HOMESTEAD NORTH AT STERLING RANCH

EARLY GRADING AND EROSION CONTROL PLANS

PCD-ENGINEERING REVIEW COMMENTS
IN BLUE BOXES WITH BLUE TEXT

PCD FILING NO.: SP-20-008

HOMESTEAD NORTH AT STERLING RANCH
 GRADING AND EROSION CONTROL PLAN
 SHEET 7 OF 10
 JOB NO. 25188.00

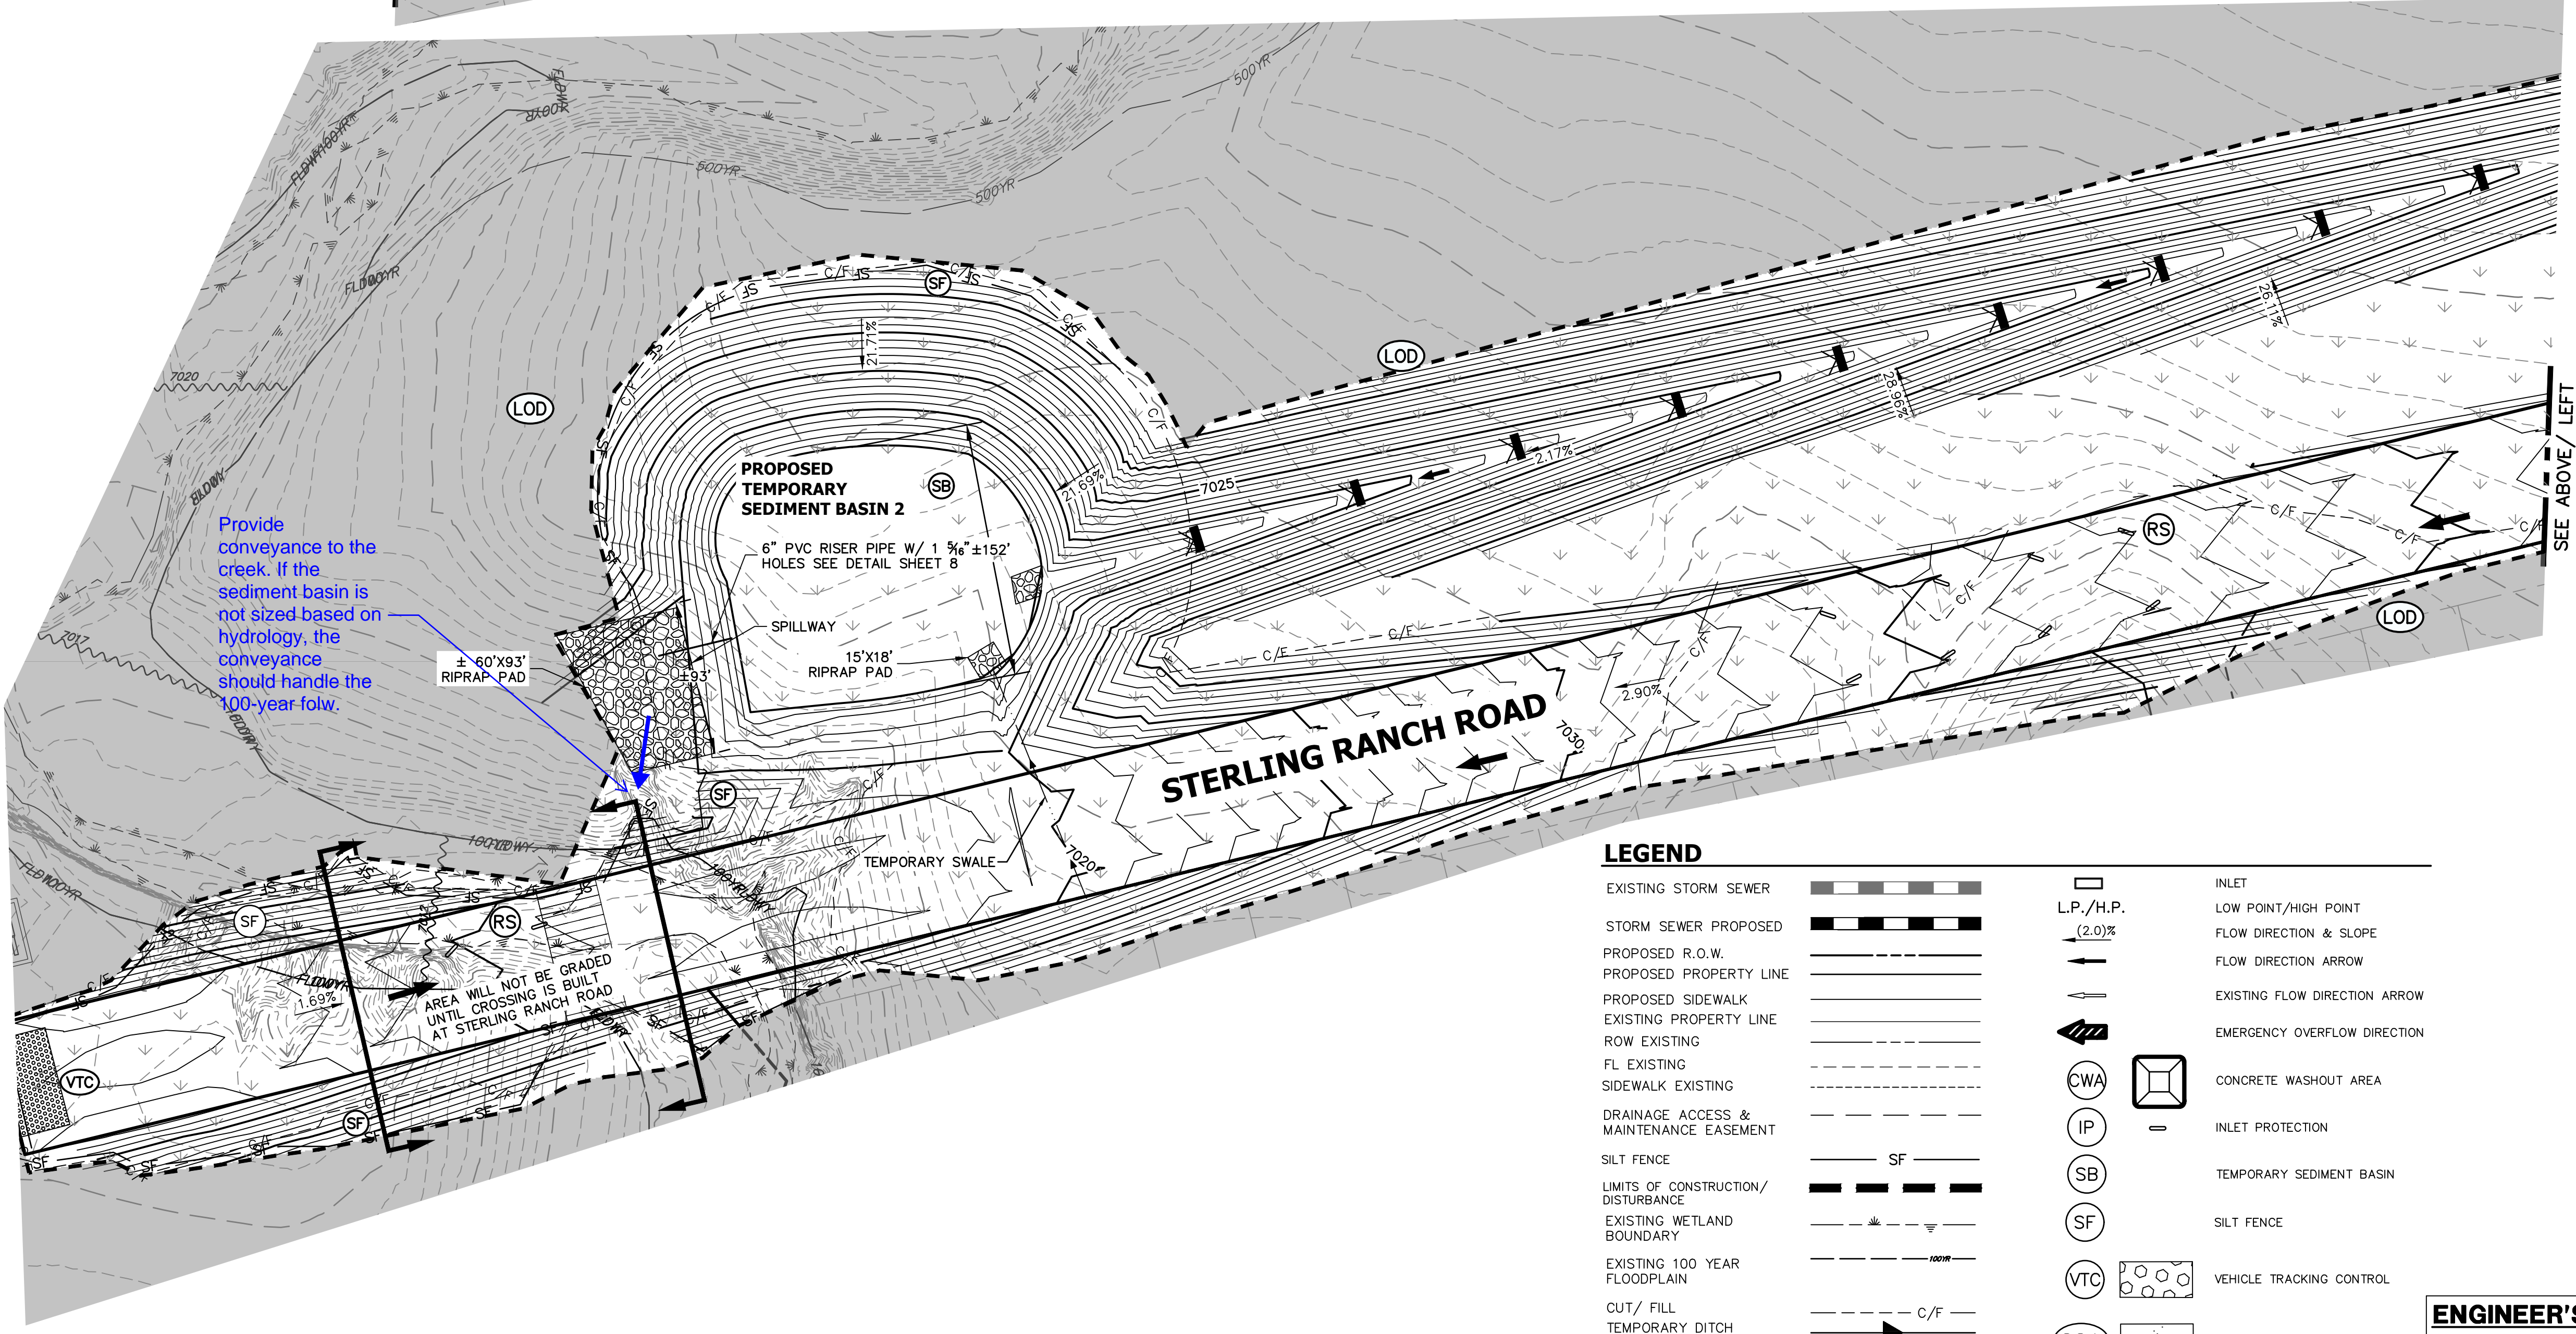
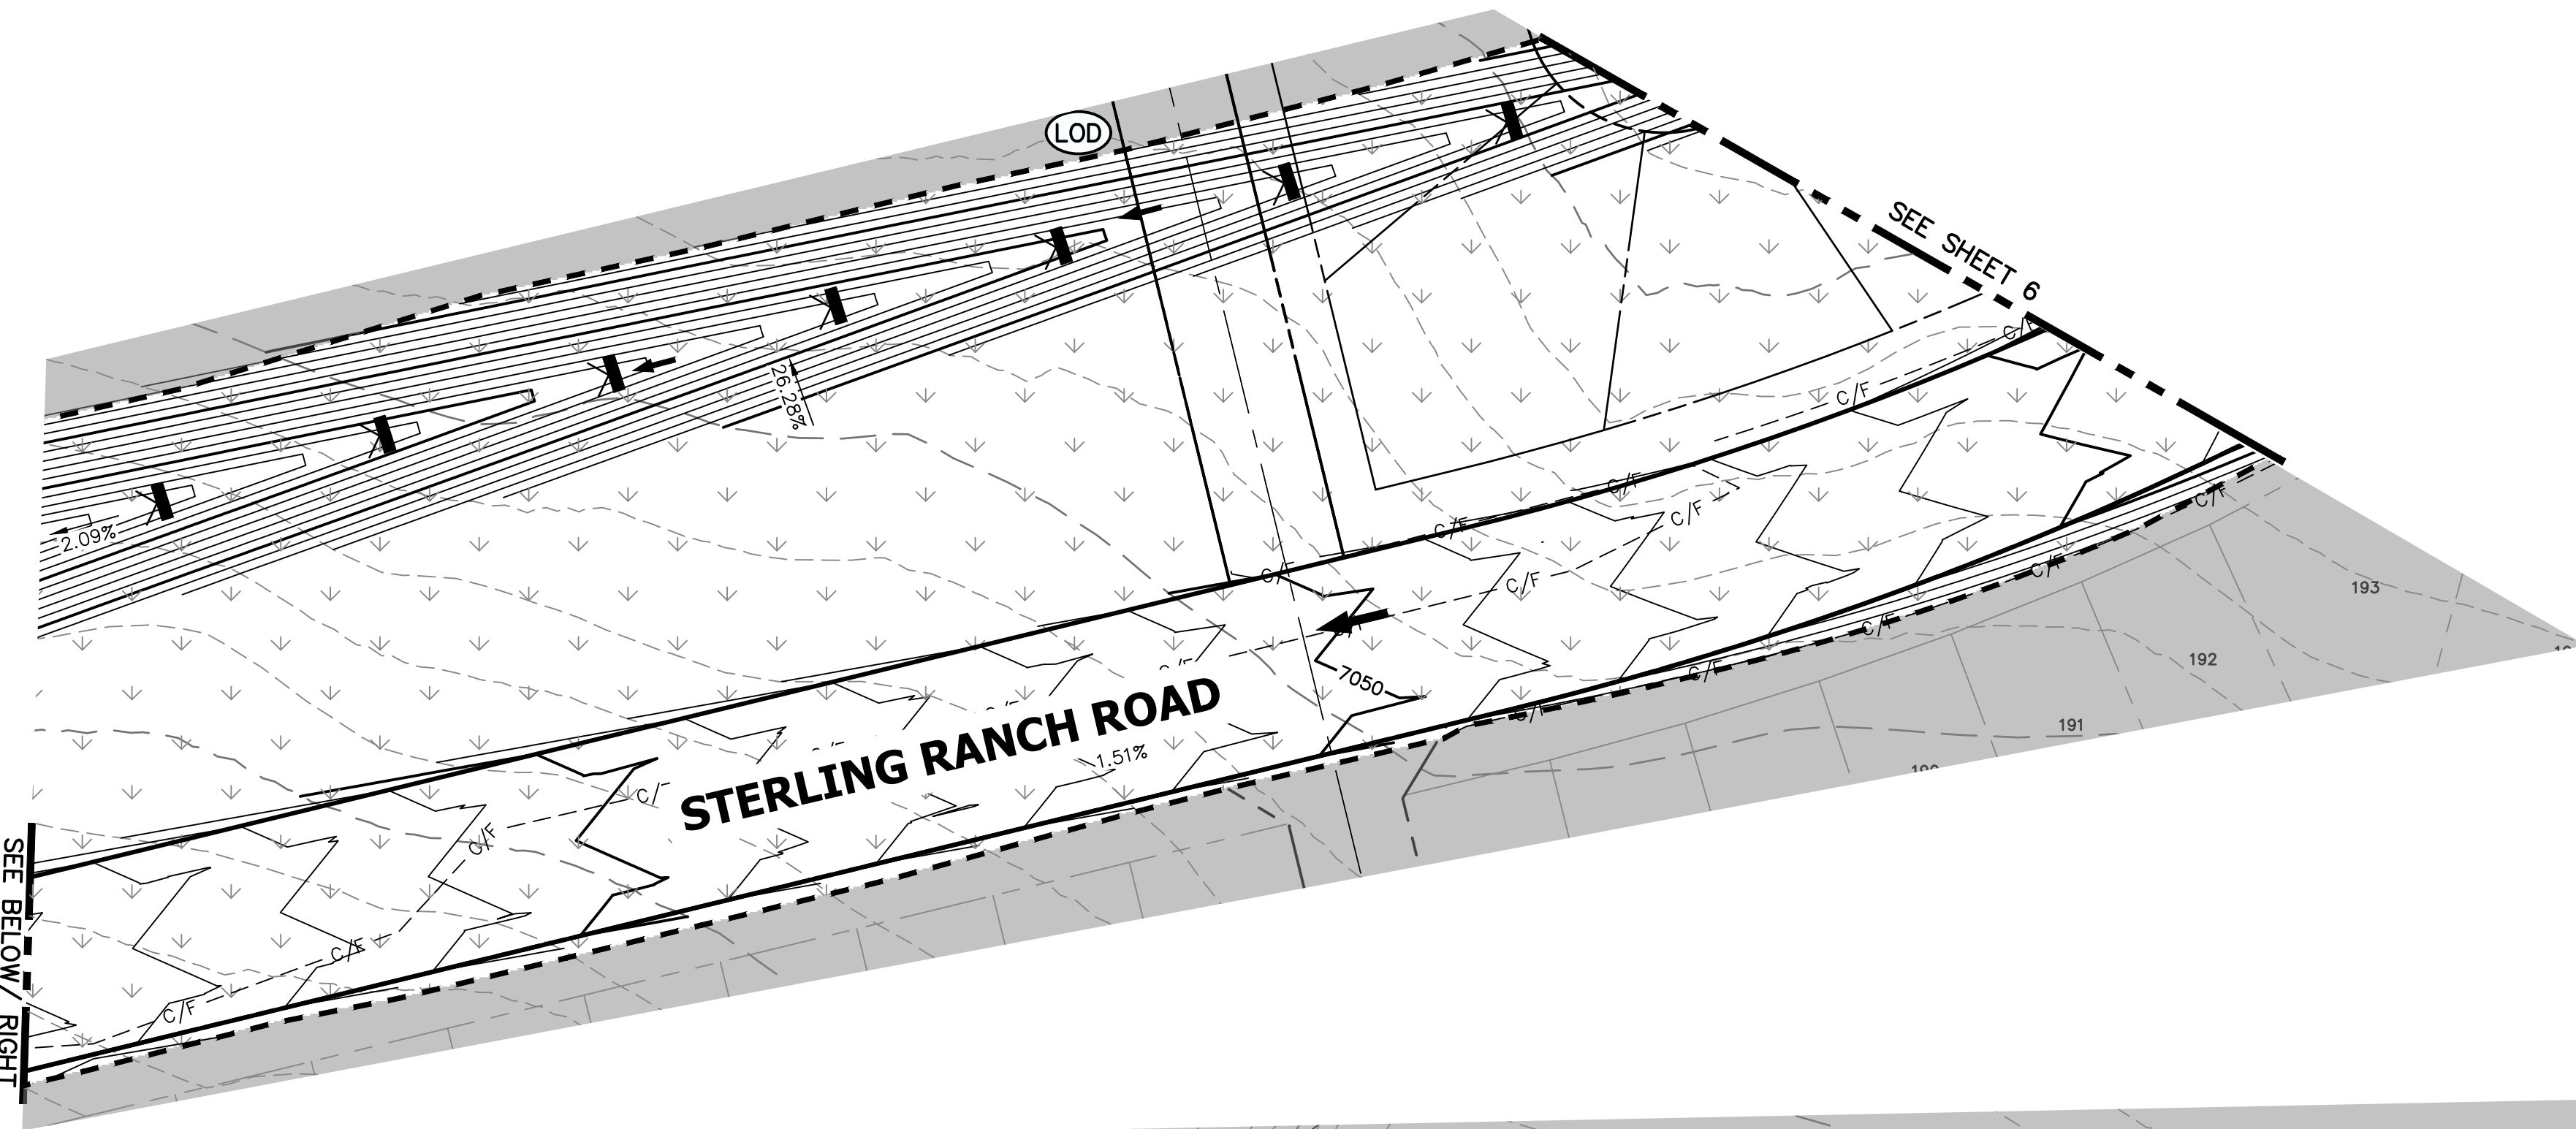
Provide conveyance to the creek. If the sediment basin is not sized based on hydrology, the conveyance should handle the 100-year flow.

TABLE SB-1. SIZING INFORMATION FOR STANDARD SEDIMENT BASIN

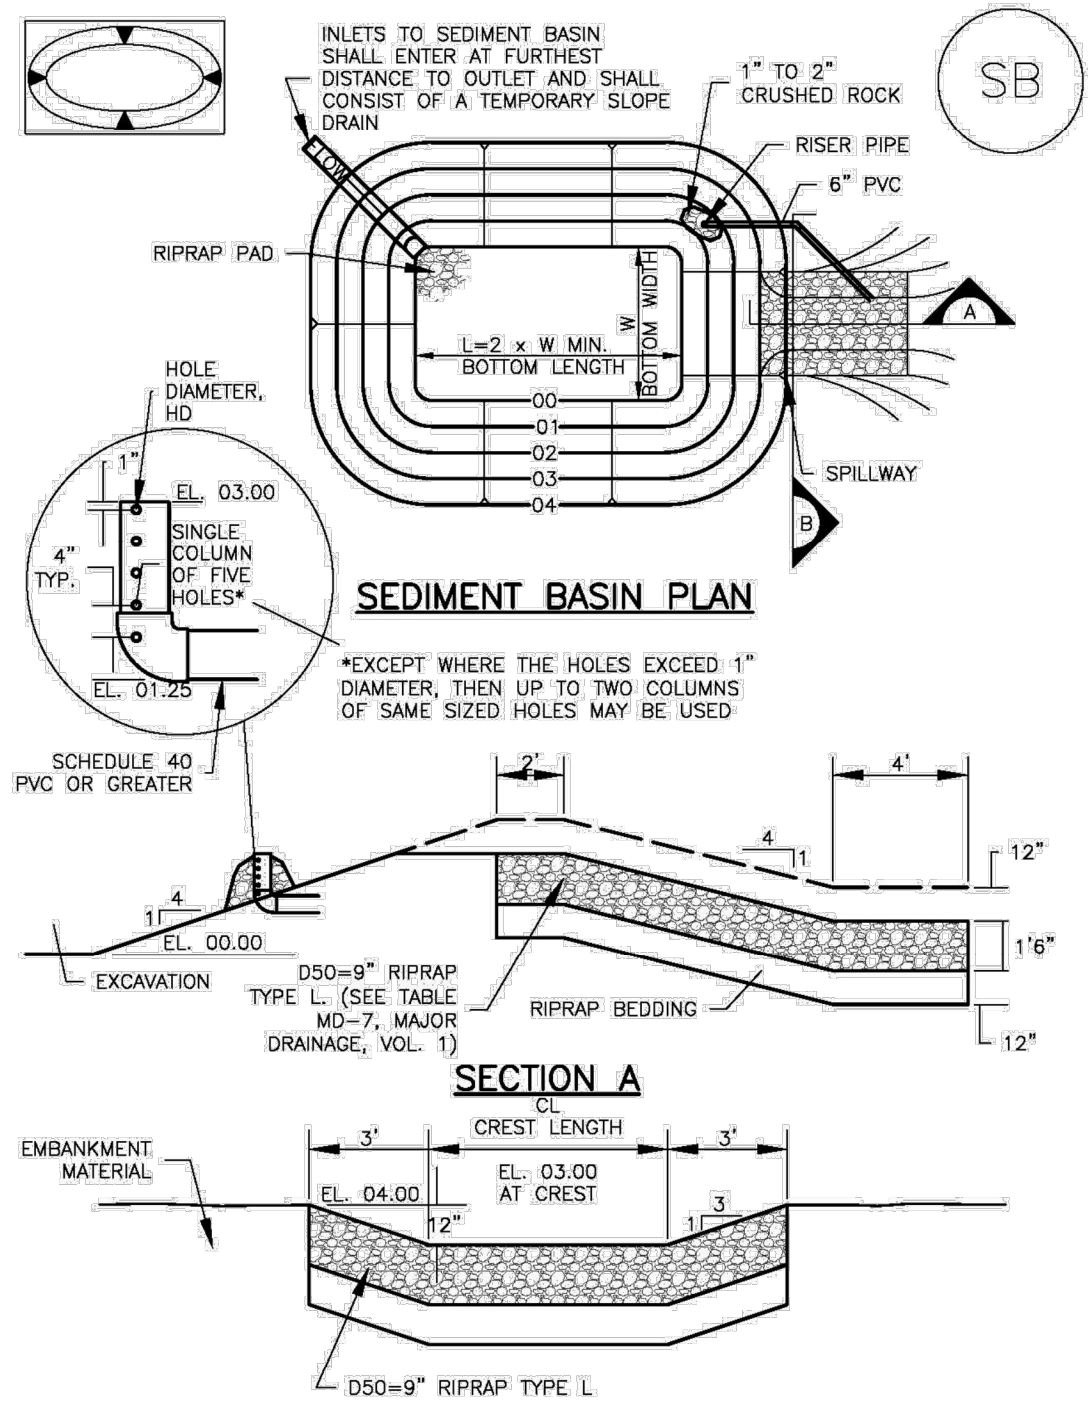
this seems low

EC-12 Check Dams (CD)

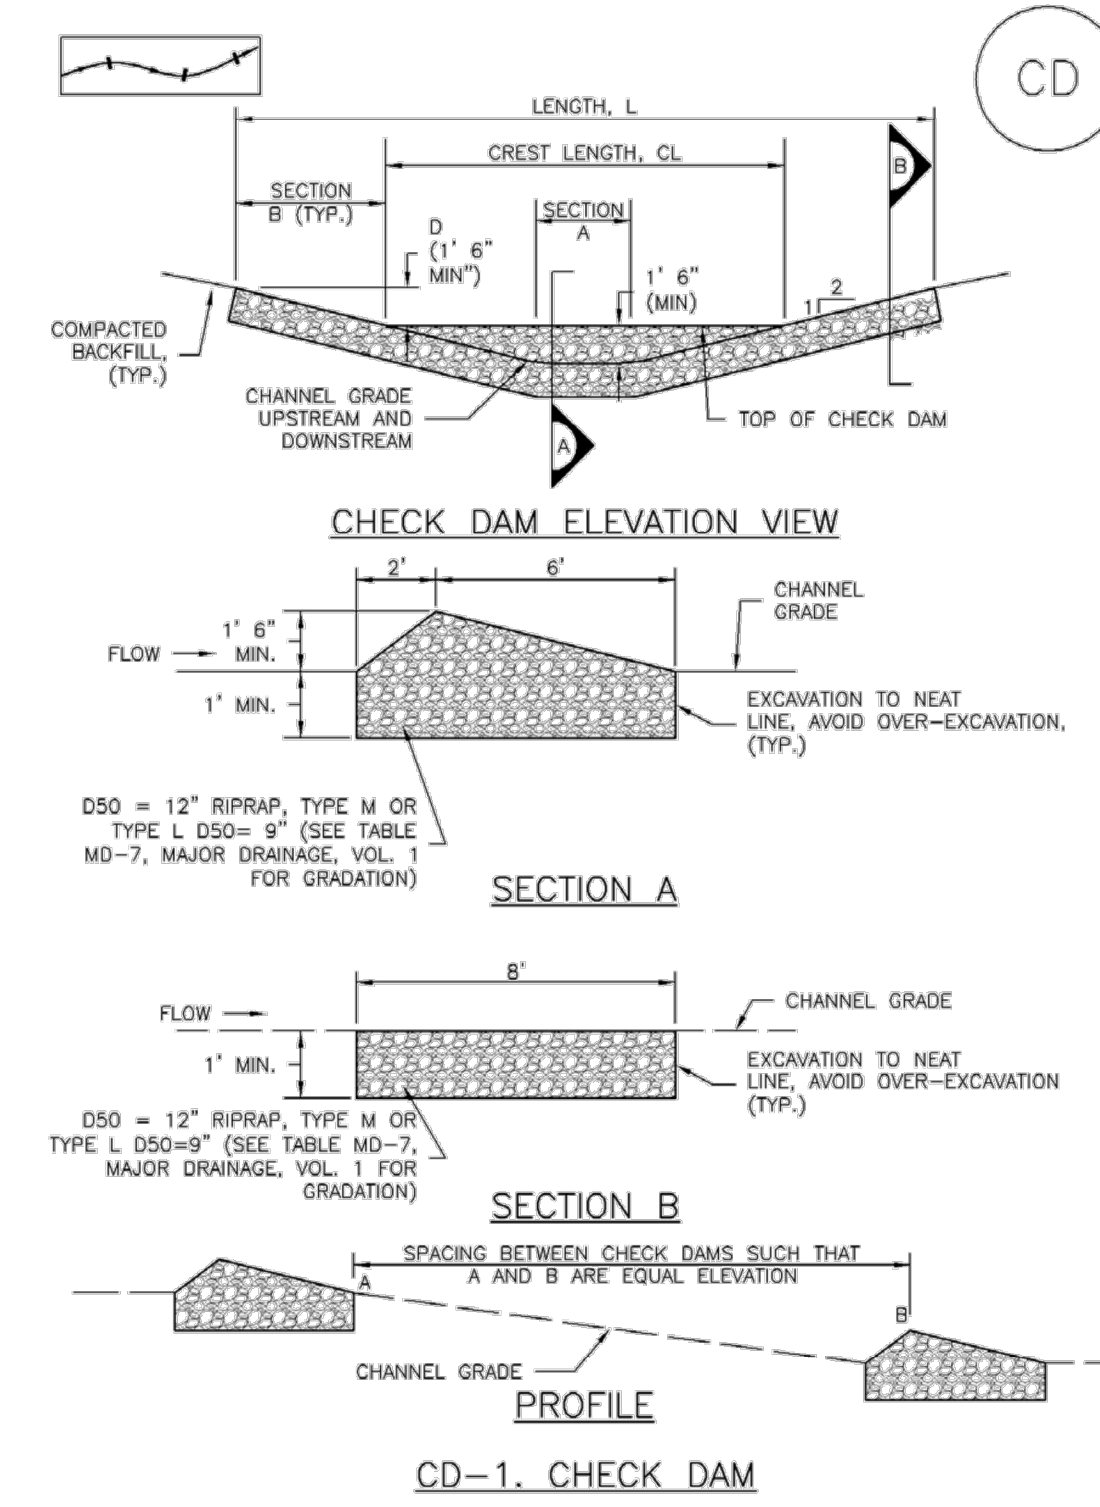
Rock socks were added to plans for V3, so also add a detail for RS's on this sheet.
 And still need a detail for rough cut street control.
 Examples of acceptable details for each are provided:
